Subject: Oyster Creek Nuclear Generating Station
Docket 50-219
Sea Turtle Incidental Capture Report 98-1

Oyster Creek Nuclear Generating Station

GPUN Responses to Request for Additional Information and Revisions Regarding Biological Assessment of Sea Turtles

Figure 3-2. Location map of OCNGS and vicinity.

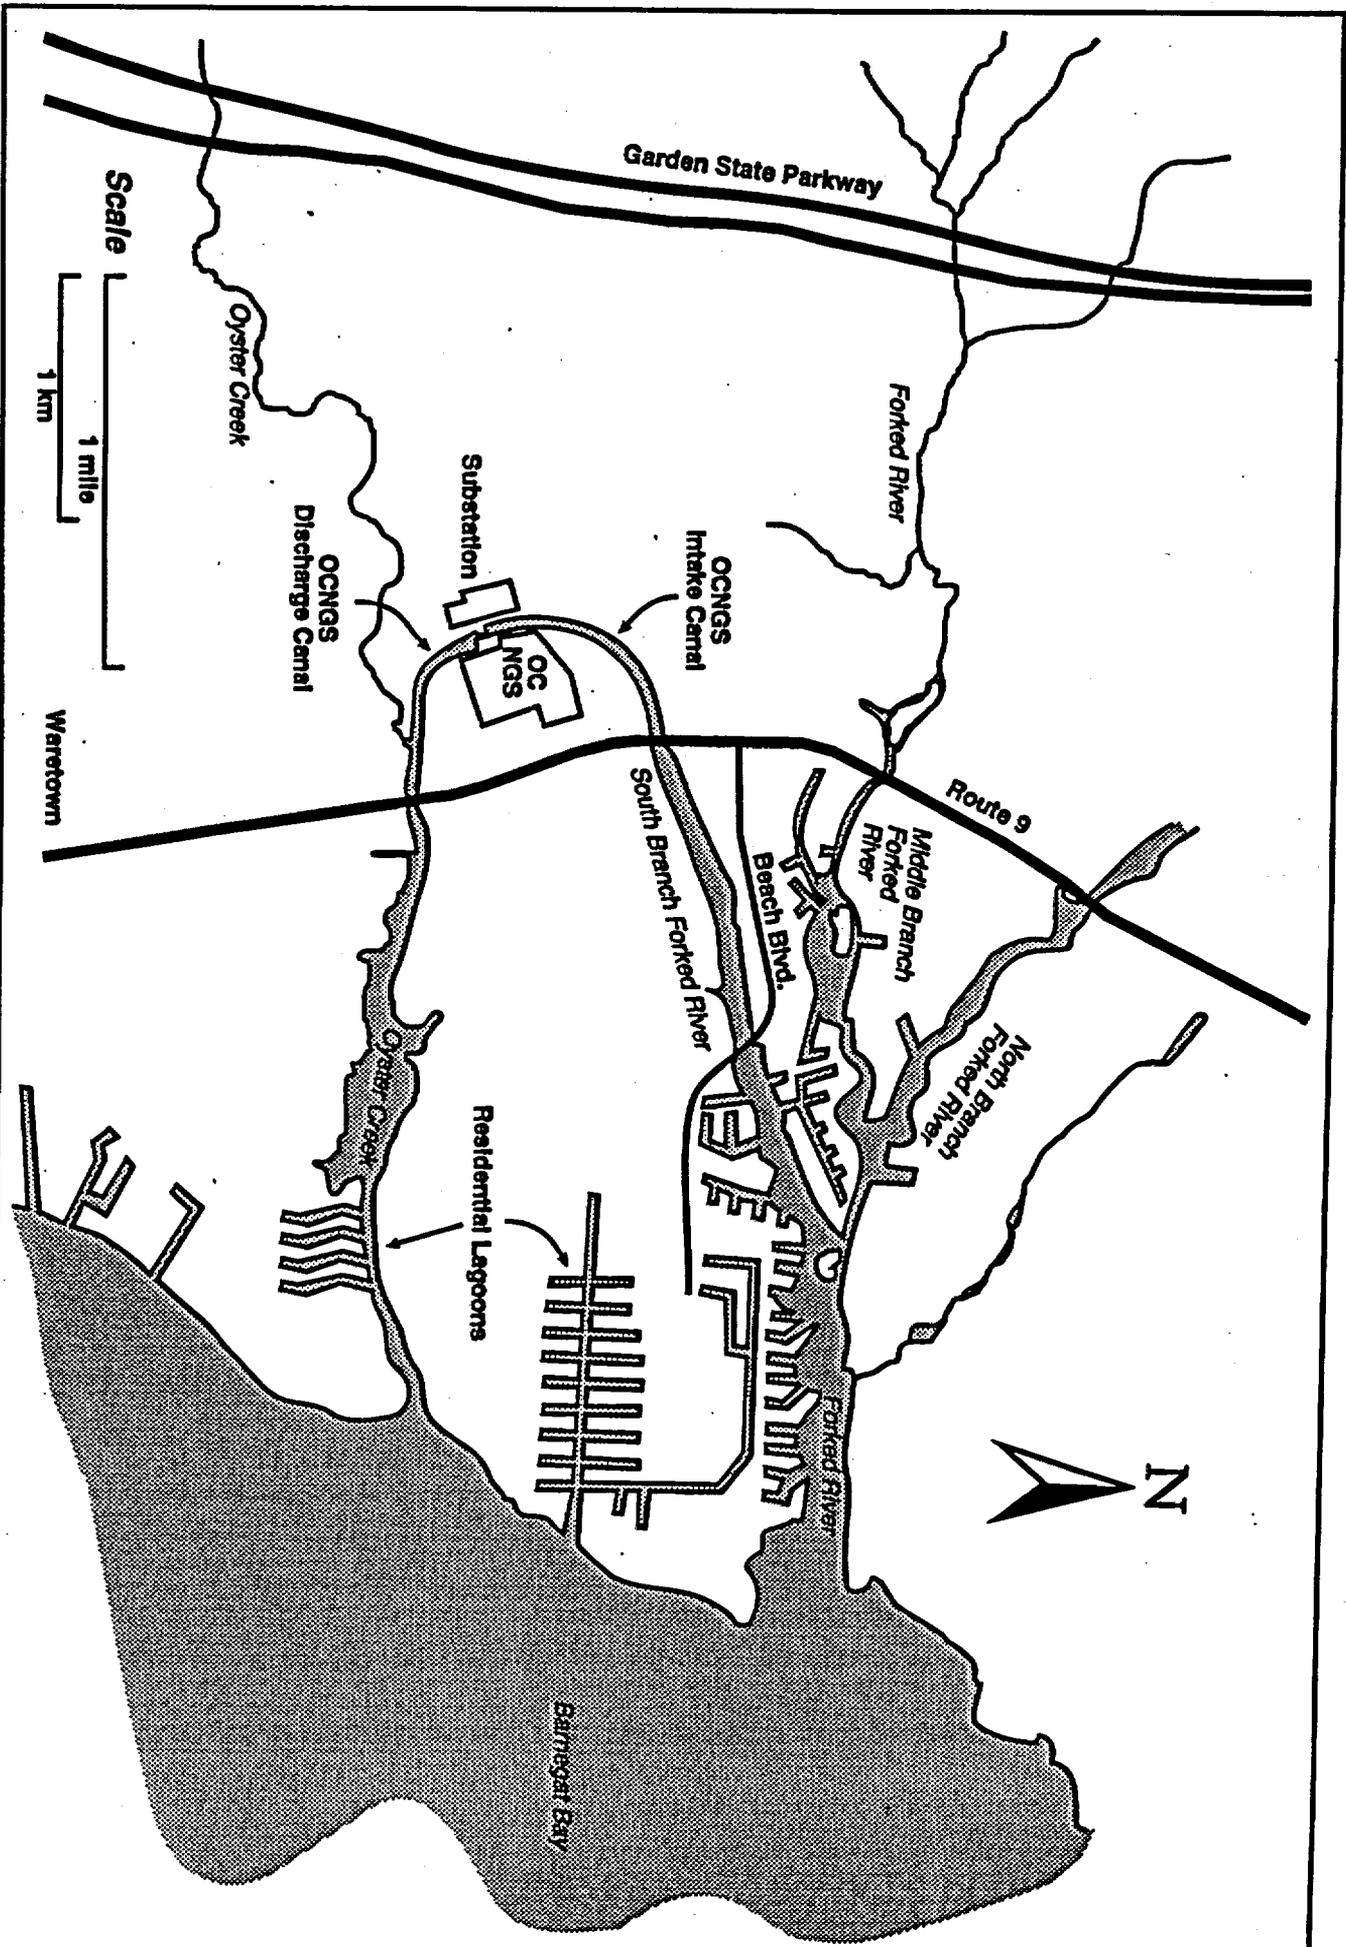
2. Figure 3-2 is very difficult to understand. A better schematic is needed.

RESPONSE: A better schematic is being developed and will be included in the revised Biological Assessment.

Figure 4-3. OCNCS Circulating System Intake Structure, section view.

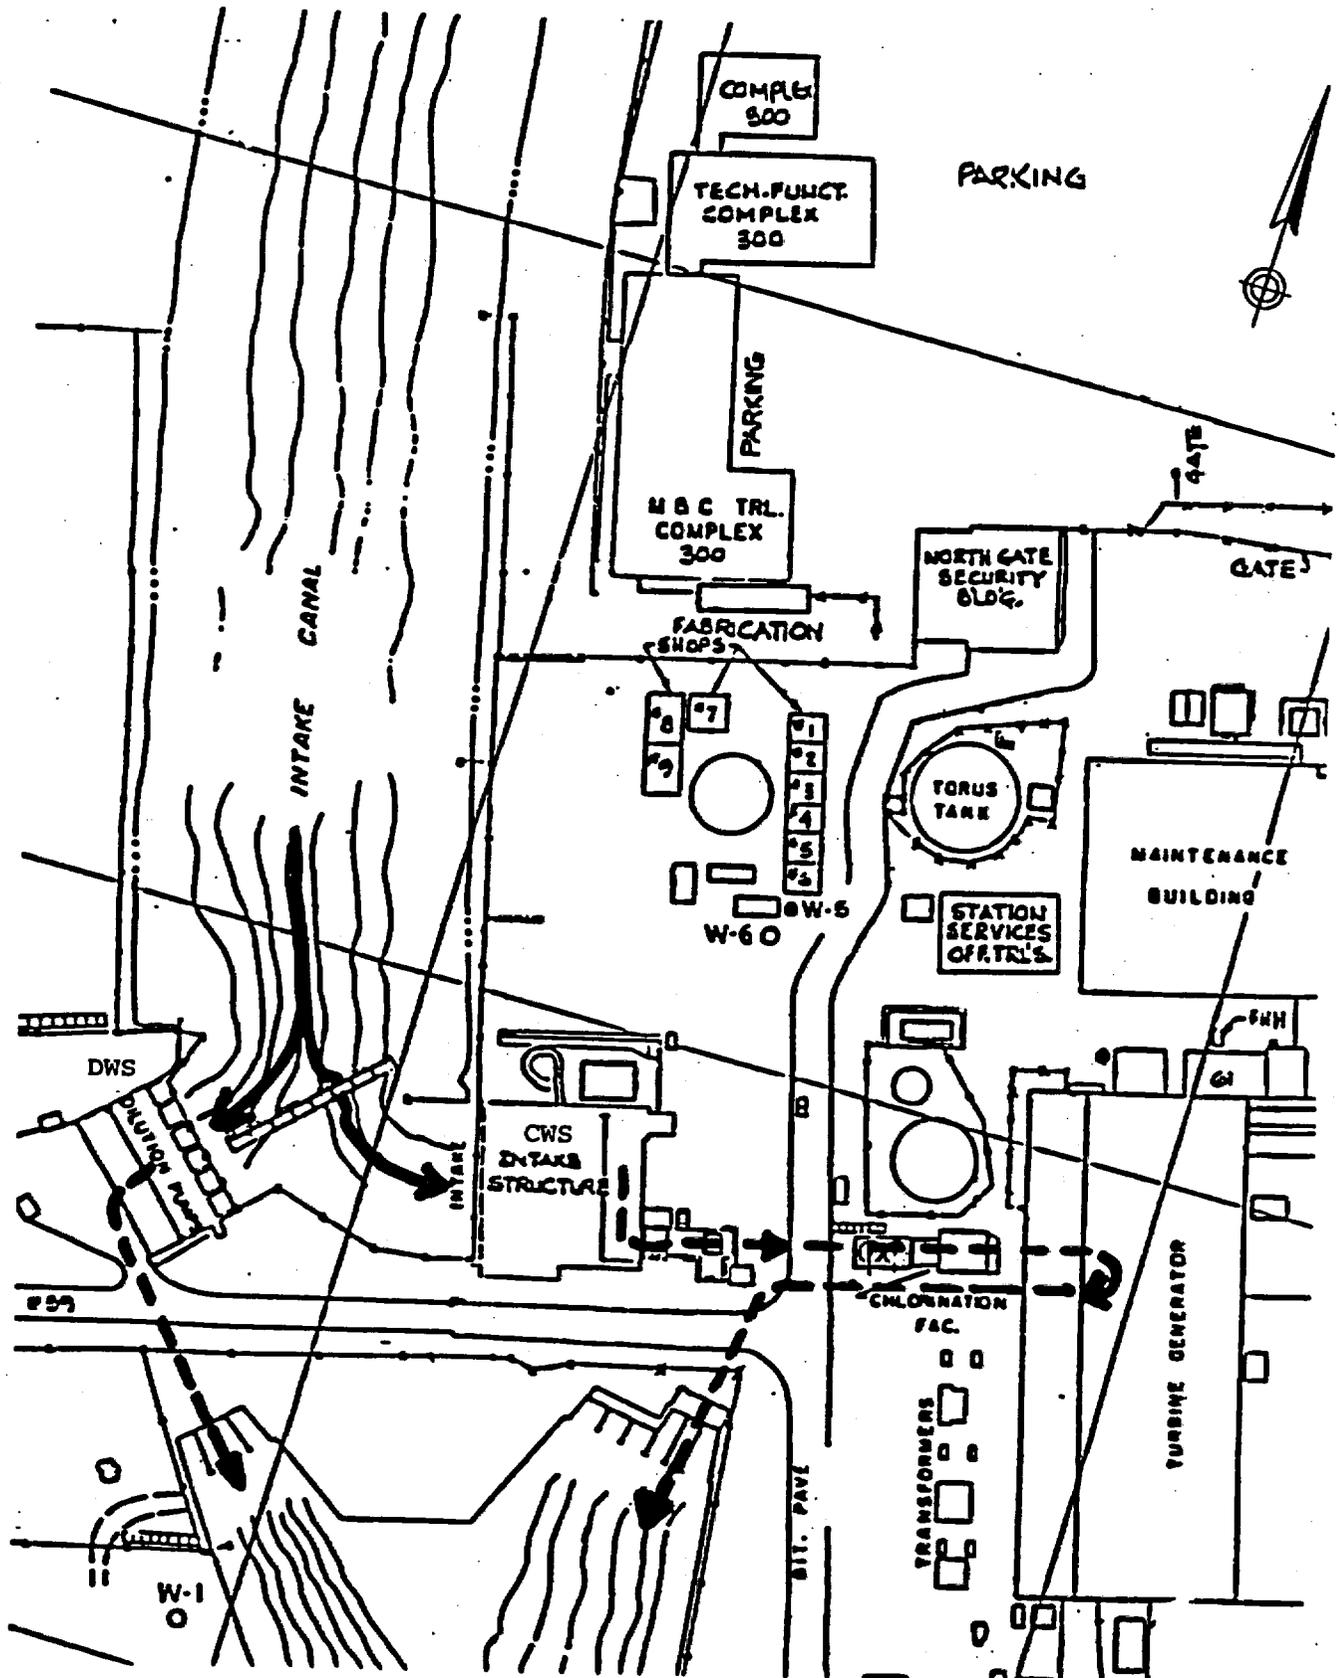
5. Page 4-4, section 4.1.2. Expand the dilution pump explanation. This is an unusual system unlike any other nuclear plant. Provide an explanation of the operating schedule and explain when the dilution pumps are used. Provide a better drawing than Figure 4-5, more along the lines of Figures 4-3 and 4-4. Include a better line drawing of the trash bars.

Improved drawings of the dilution pumps and trash bars are being developed and will be included in the revised Biological Assessment.

Figure 4-6. OCNGS Dilution Water System Intake Structure, Section View.

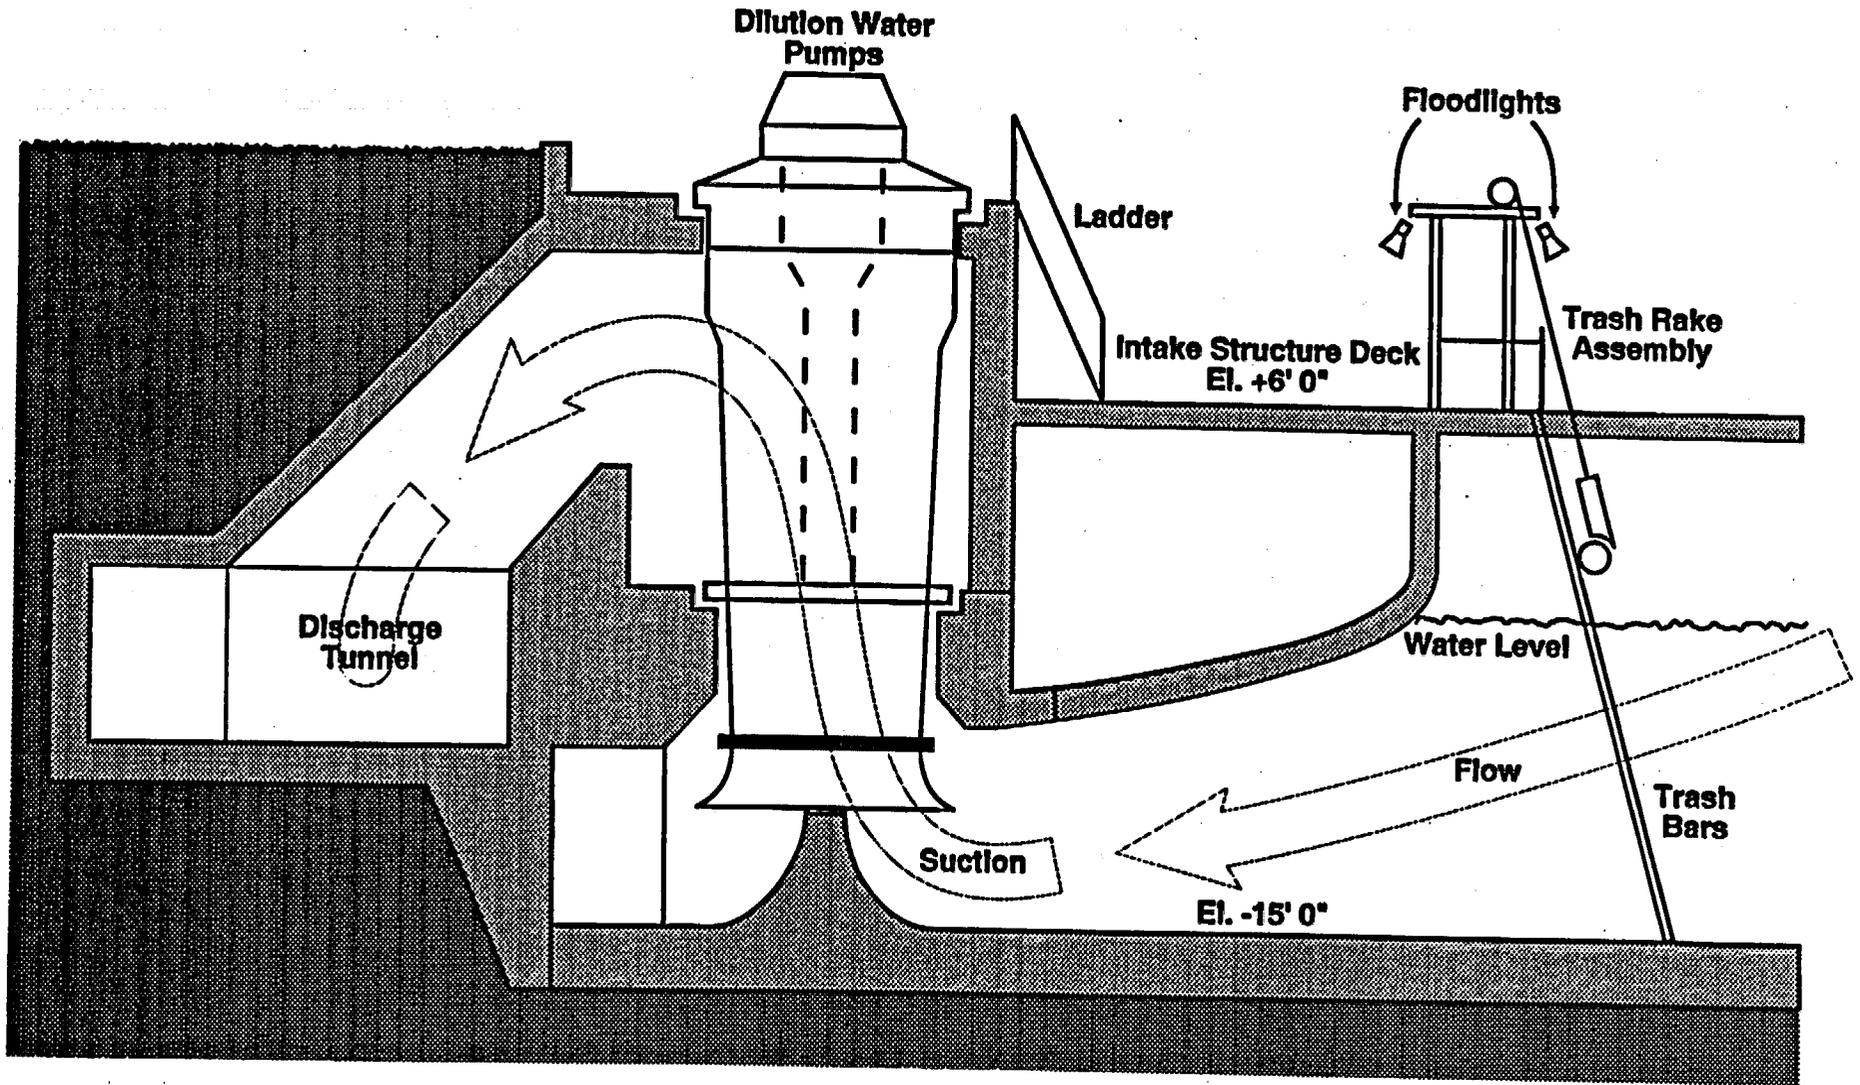
6. Figures 4-6 and 4-7 are not applicable and can be deleted.

RESPONSE: These figures will be deleted.

Figure 5-1. Generalized sea turtle life cycle (After PSE&G 1989).

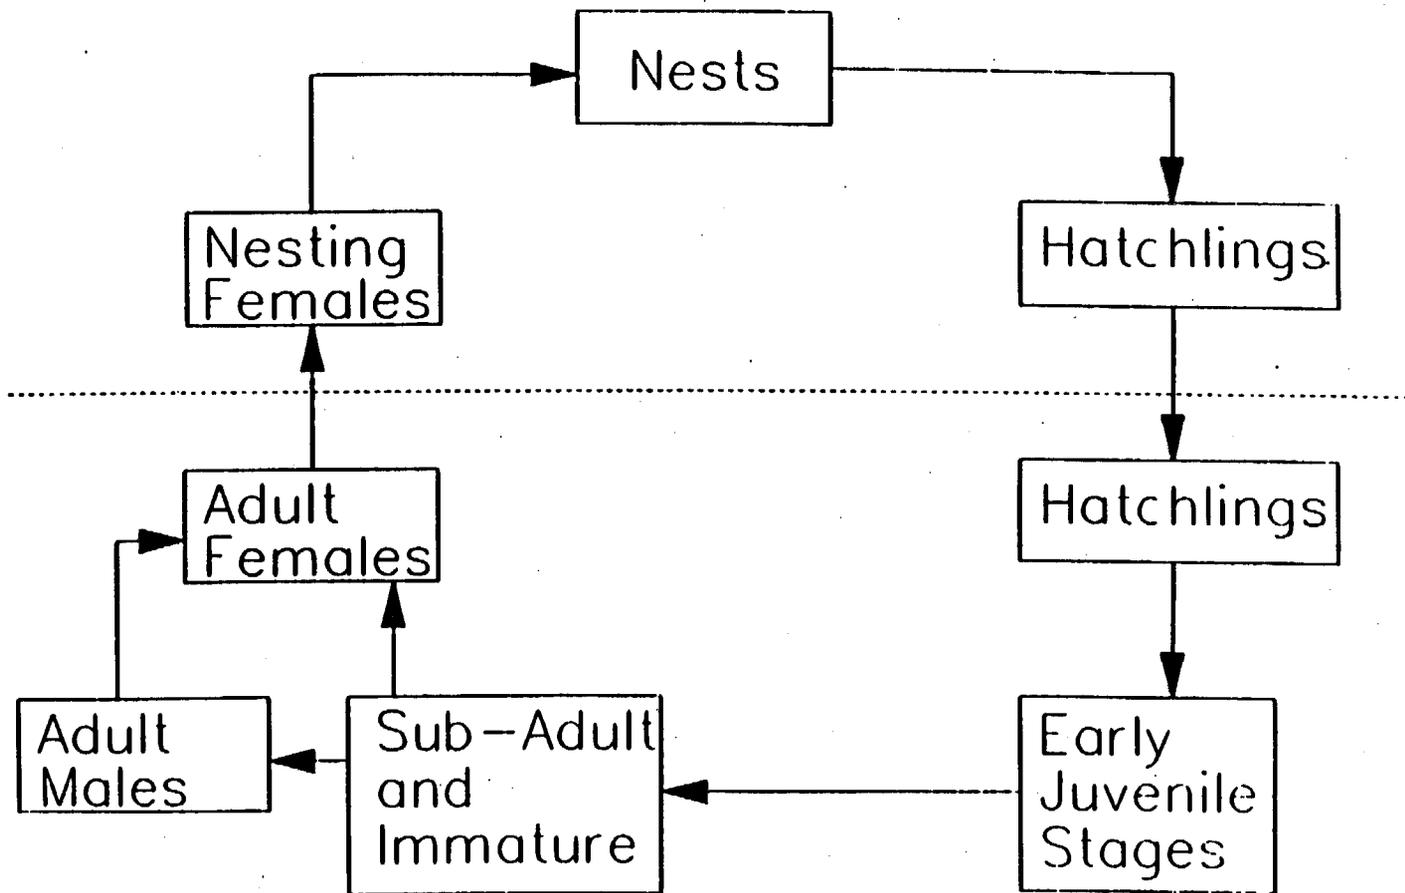
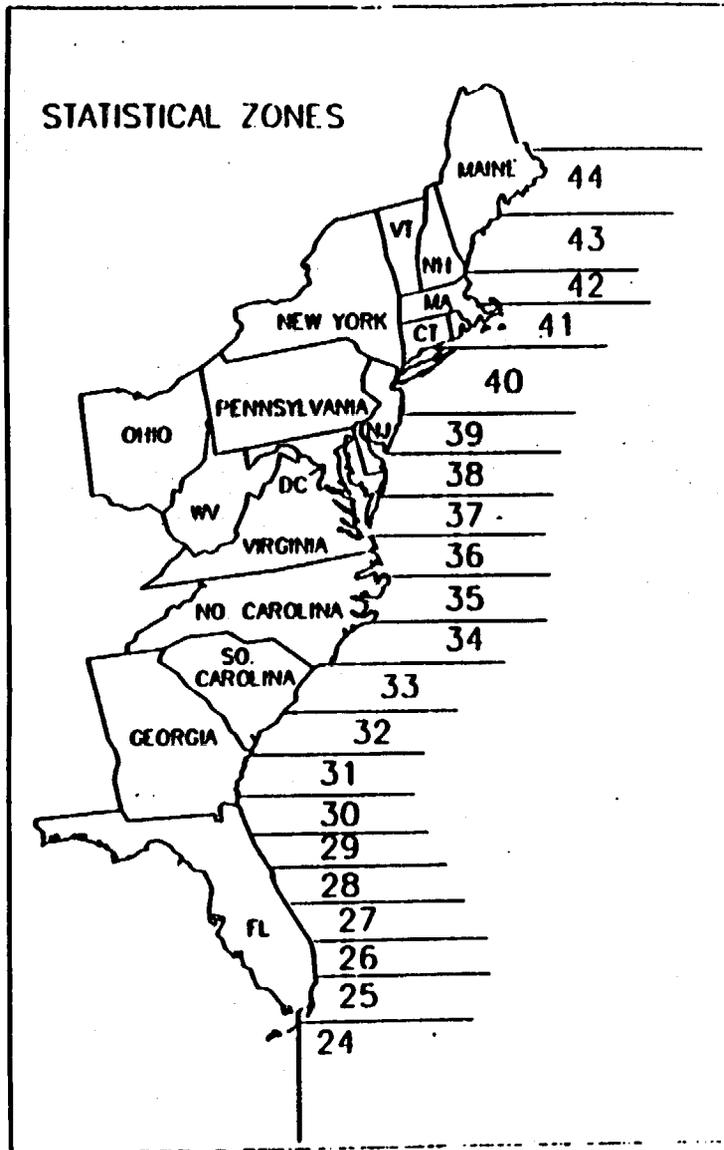
9. Figure 5-1, Is there stranding data for 1993? If so, provide this information (by county, if available).

RESPONSE: GPUN is attempting to obtain this information and will include whatever is available in the revised Biological Assessment.

Figure 5-5. Number of Kemp's Ridley Nests at Rancho Nuevo Before and After Implementation of TED Regulations (Byles, 1994).

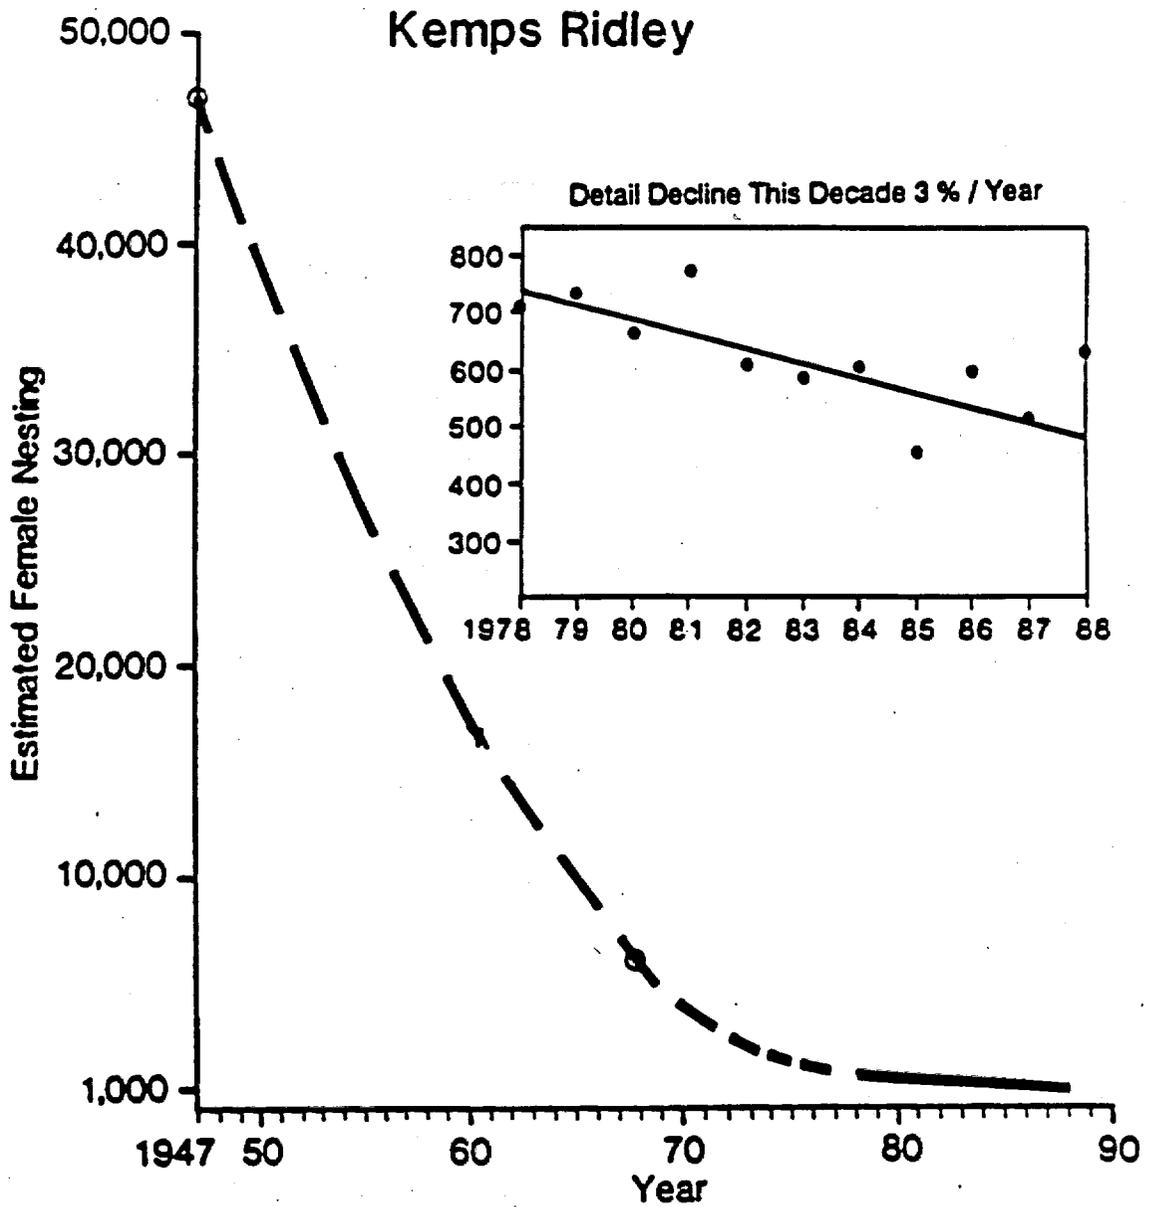
10. Figure 5-5. Is there nesting information for 1992, and 1993? If so, provide this information, as well as delineating any New Jersey specific nests.

RESPONSE: GPUN is attempting to obtain this information and will include whatever is available in the revised Biological Assessment.
